Final Report

Manville WSC Permit Applications Review: Pumping Simulations

Prepared for:

James Totten, General Manager
Lost Pines Groundwater Conservation District
908 N W Loop 230
Smithville, TX 78957
512-360-5088

Figure 2. Groundwater Elevation Hydrograph (Manville WSC Well Sites)

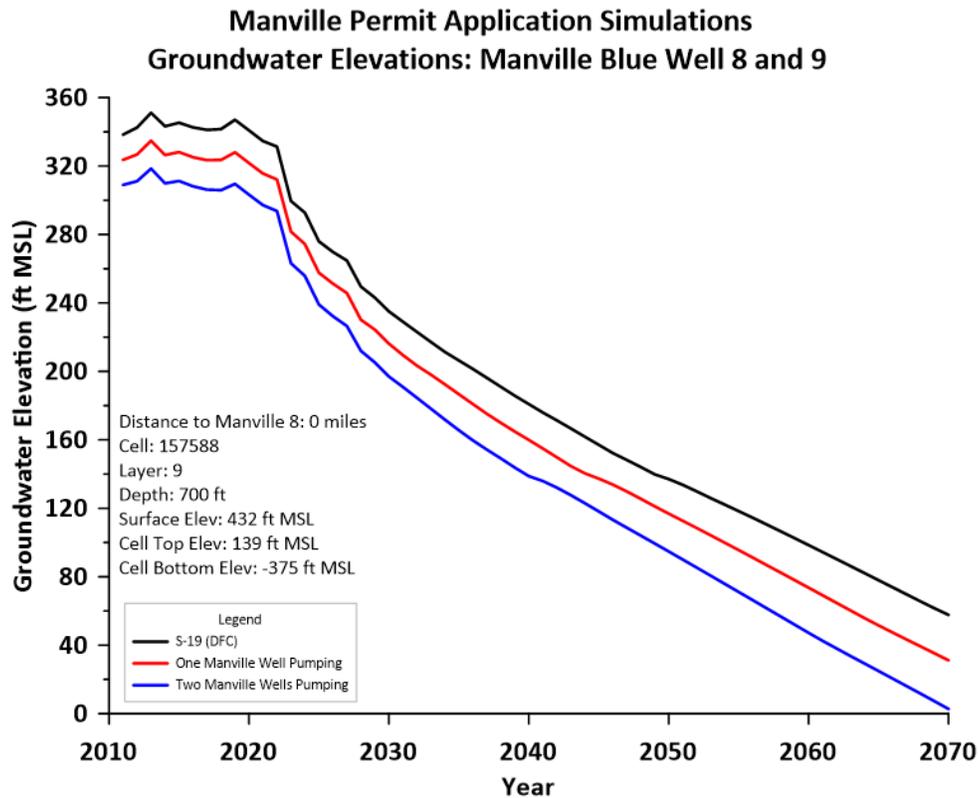
- Figure 2 presents the comparison of groundwater elevation in the proposed Manville WSC well sites for the DFC run (Run S-19) and the two pumping simulations.
- Figure 3 presents the attributable drawdown of the proposed Manville WSC pumping (one well and two wells) at the proposed Manville WSC wells sites.
- Appendix A presents the groundwater elevations and attributable drawdown hydrographs for the eight monitoring wells sites.
- Table 6 summarizes the attributable drawdown at all well sites due to the proposed pumping of the Manville WSC wells.

Figure 3. Attributable Drawdown Hydrograph (Manville WSC Well Sites)

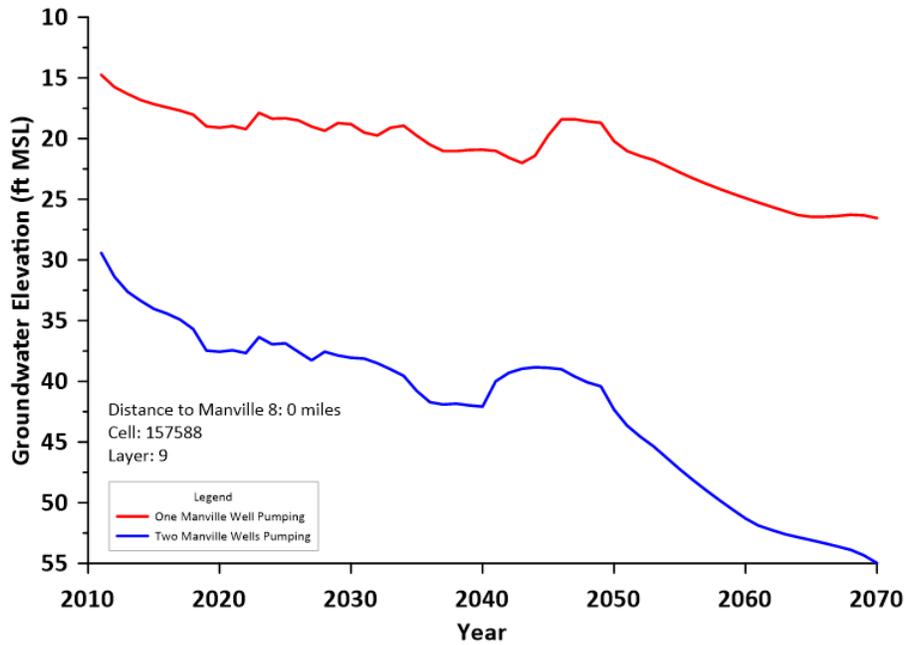
- Proposed pumping volume = 3,064 AF/yr
- Drawdown from 2011 to 2070 at well site = 55 ft
- Significant sources of the proposed pumping (> 10% of production):
 - Induced inflow from Milam County
 - Vertical inflow from the overlying Calvert Bluff formation
 - Storage reduction in the Simsboro Aquifer
